M54 to M6 Link Road TR010054

Environmental Statement Addendum: Proposed Scheme Changes October 2020

**Environmental Statement Addendum: Proposed Scheme Changes
October 2020**

Regulation Number	Regulation 5(2)(a)
Planning Inspectorate Scheme Reference	TR010054
Application Document Reference	8.6
Author	M54 to M6 Link Road Project Team and Highways England

**FIGURE 1:
DESIGN COMPARISON**

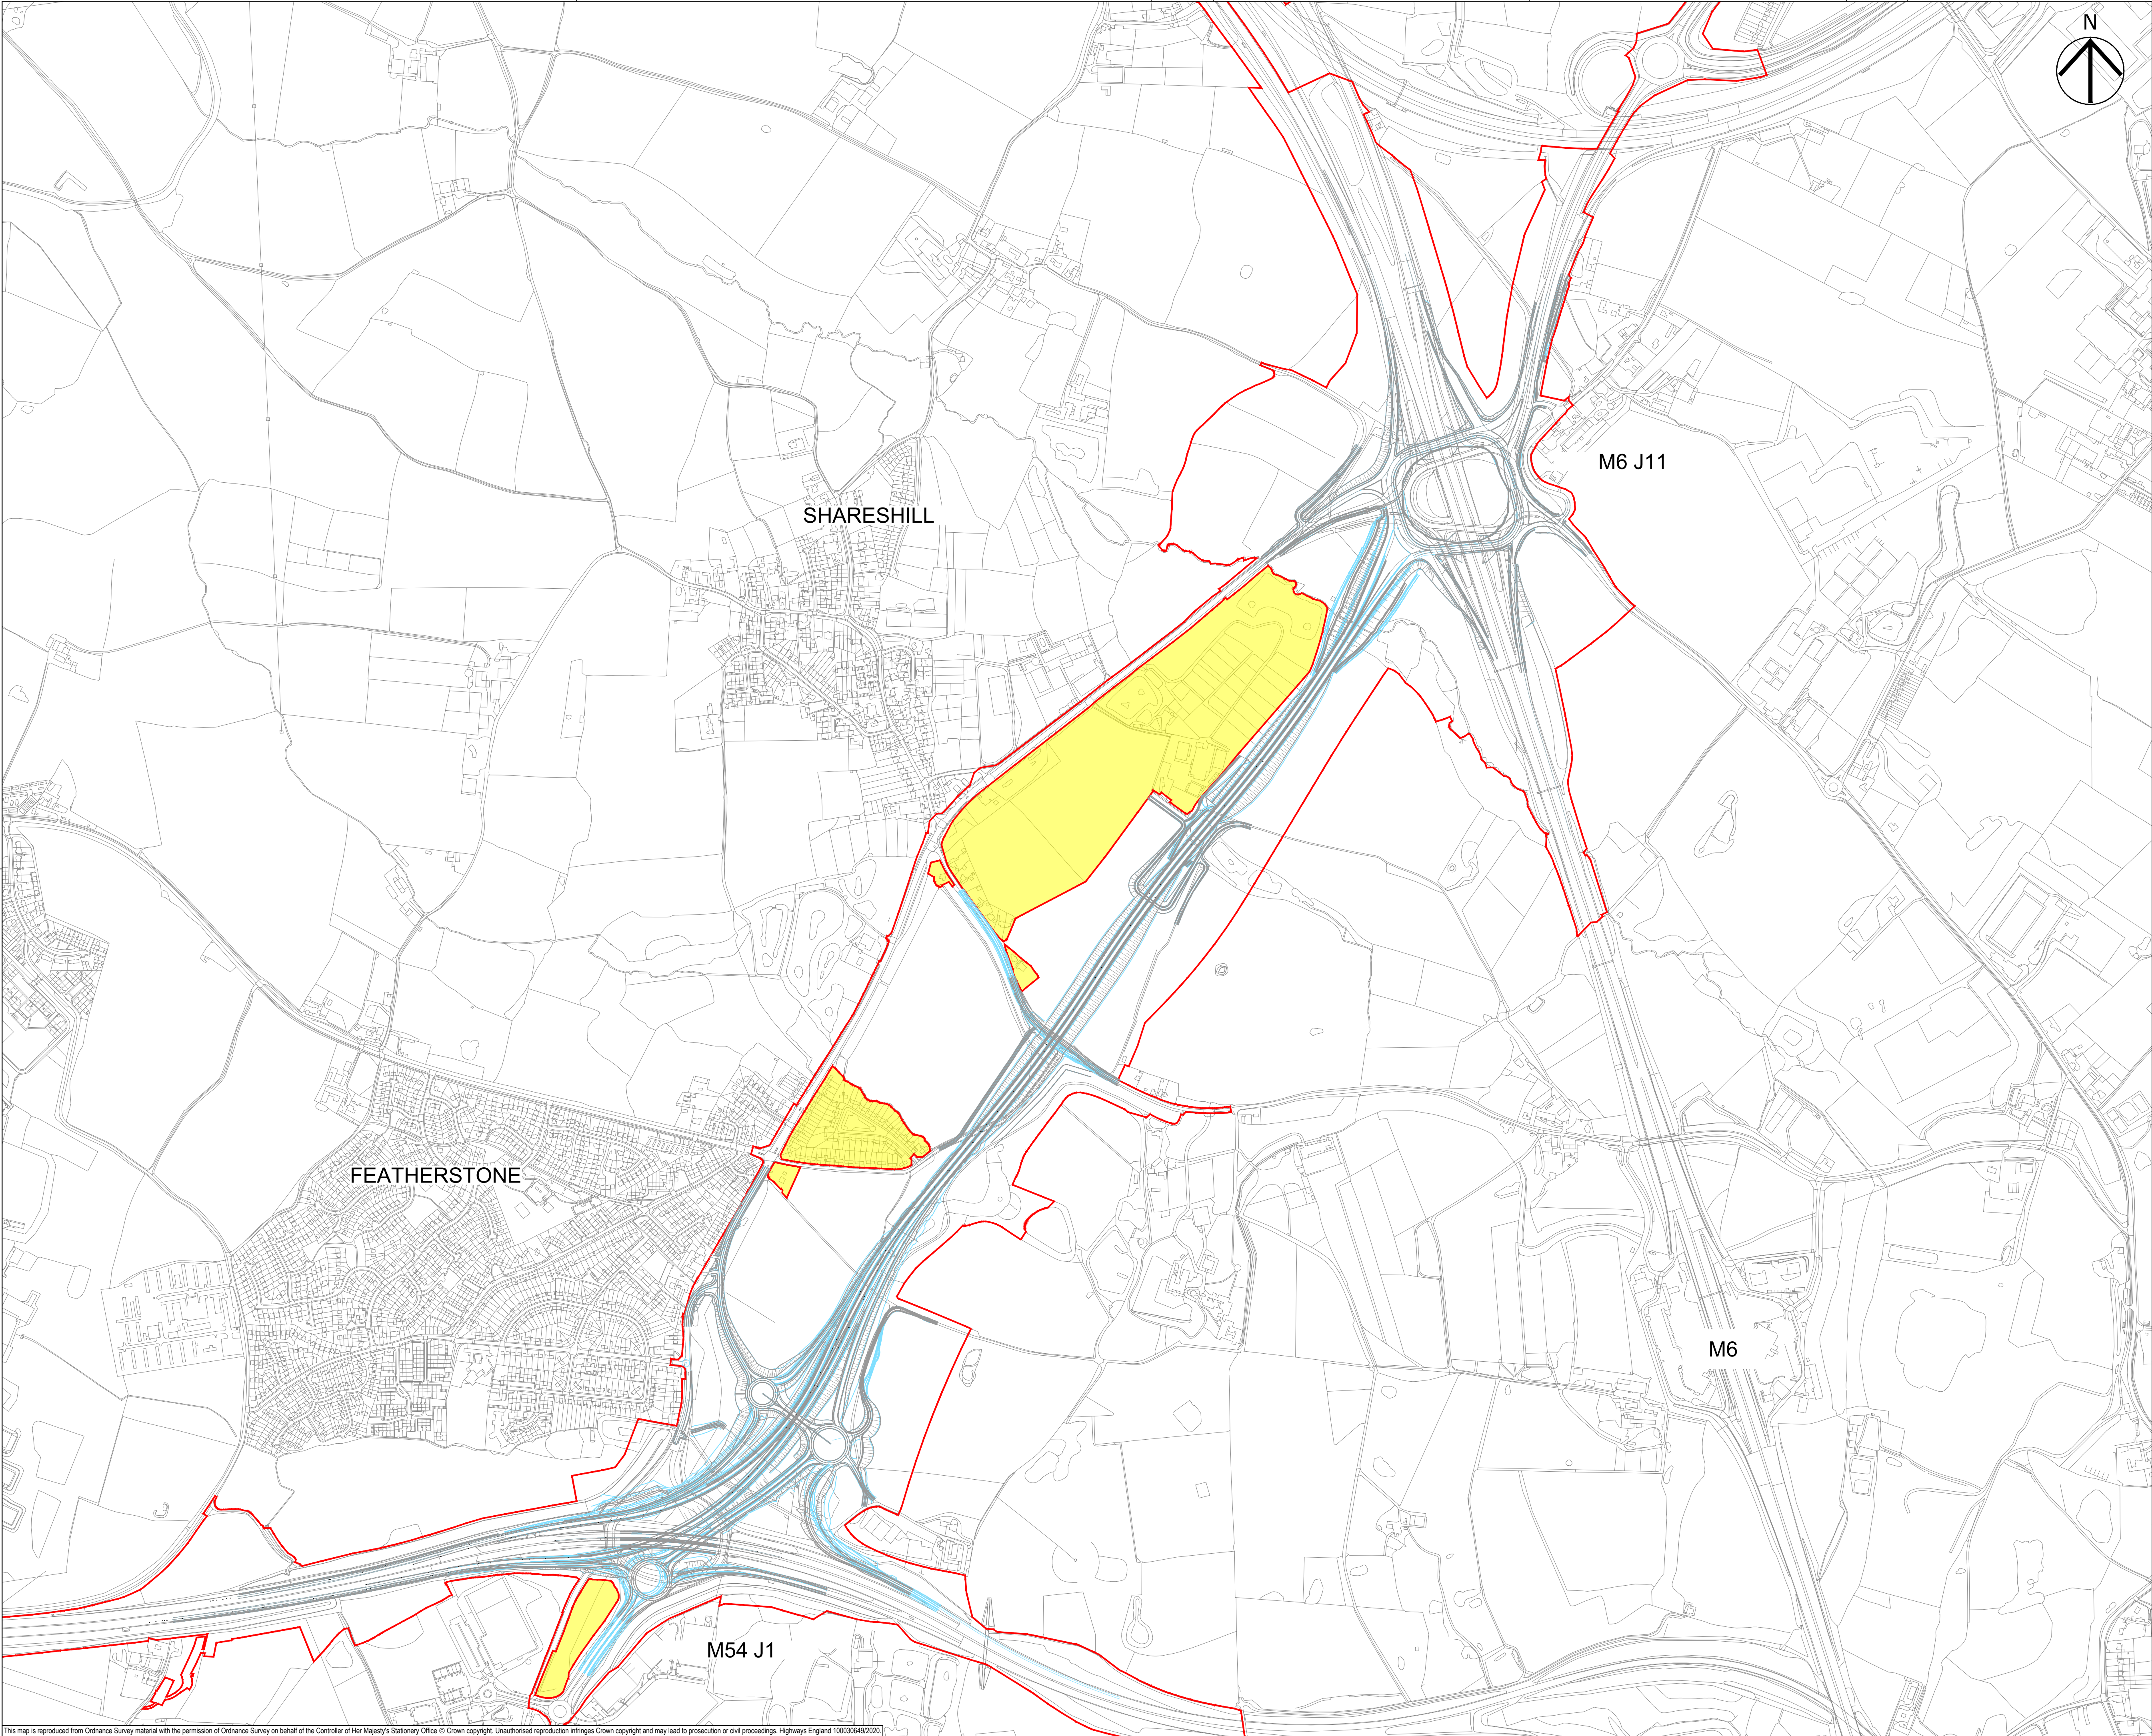
- 2.1.3. Table 2.1 sets out the differences between the Scheme as submitted to the Planning Inspectorate in January 2020 and the design changes assessed in this technical note. The differences between the two designs (Changes 1 - 6) are shown in Figure 1. The changes to the Environmental Masterplans are highlighted in Figure 2.

Element of the Scheme affected	Post- submission design change
M54 Junction 1	<div data-bbox="421 459 1160 1394"> <p>Change 1) M54 Junction 1 eastbound diverge to Featherstone</p> <p>This change proposes to omit the near straight from the M54 Junction 1 eastbound diverge to Featherstone, reducing the length of the slip road. This allows the diverge to be relocated further downstream and reduces the extent of widening through the existing earth bund north of the M54.</p> <p>Change 4) M54 Junction 1 change to bridge structure</p> <p>This change would alter the main structure at M54 Junction 1 where the M54 passes over the junction. The main structure (currently 112m span) would be altered to two smaller structures that can be constructed adjacent to the M54 at the site compound and then moved into their final position. Given the reduced structure size there is an opportunity to shift the alignment of the road under the structure (by approximately 20m) and reduce the size of Junction 1.</p> <p>This alteration to the design would result in a significant reduction in the period for which traffic management has to be in place, with a temporary closure of the M54 for approximately three weeks with a diversion route in place, rather than approximately two years of complex traffic management. This would reduce the overall construction programme by six months.</p> <p>The signed diversion route, eastbound, will encourage drivers to proceed along the M54 to Junction 2, head north along the A449 and then turn-right at A449/A5 Gailey Island along the A5 to M6 Junction 12. Westbound drivers will be encouraged to use the M6 Junction 12 and travel along the A5 westbound, turn left at A5/A449 Gailey Island and head south</p> </div> <div data-bbox="1173 459 2027 1394">  <p>Light blue lines illustrates the design submitted with the DCO application in January 2020, the grey lines illustrate the design change as assessed in this report.</p> </div>

Element of the Scheme affected	Post- submission design change	
Approach to M6 Junction 11	<p>Change 3) Increase gradient of the incline on the approach to Junction 11, reducing the embankment height at Latherford Brook</p> <p>The height of the proposed embankment south of M6 Junction 11 has been reduced resulting in a steeper incline towards the M6 Junction 11. This change reduces the vertical height of the embankment by approximately 0.7 m as it crosses over Latherford Brook. The width of the embankment would be reduced from 105 m at its widest point to 85 m, moving the base of the south-eastern side of the embankment up to 6.5 m away from the Brookfield Farm ancient woodland and the western side up to 12.5 m from the fishing pond at Brookfield Farm. A minor change has also been incorporated to the diversion route of Saredon Footpath (FP) 8 PRow as a result of changes to the embankment. The diversion would follow the existing alignment of the PRow more closely, utilising the existing crossing point over Watercourse 5 (Latherford Brook).</p>	 <p>Light blue lines illustrate the design submitted with the DCO application in January 2020, the grey lines illustrate the design change as assessed in this report.</p>

Hilton Lane Bridge	<p>Change 5) Relocation of Hilton Lane Overbridge and change to PRow</p> <p>Hilton Lane bridge would be constructed approximately 12 m north of the submitted design. The bridge would be constructed off-line which would avoid the need for a temporary diversion.</p> <p>A short section of new footway would be provided adjacent to the eastbound carriageway of Hilton Lane where the road crosses over the Scheme on Hilton Lane Bridge to provide a diversion route for Shareshill FP 5. The footway would no</p>
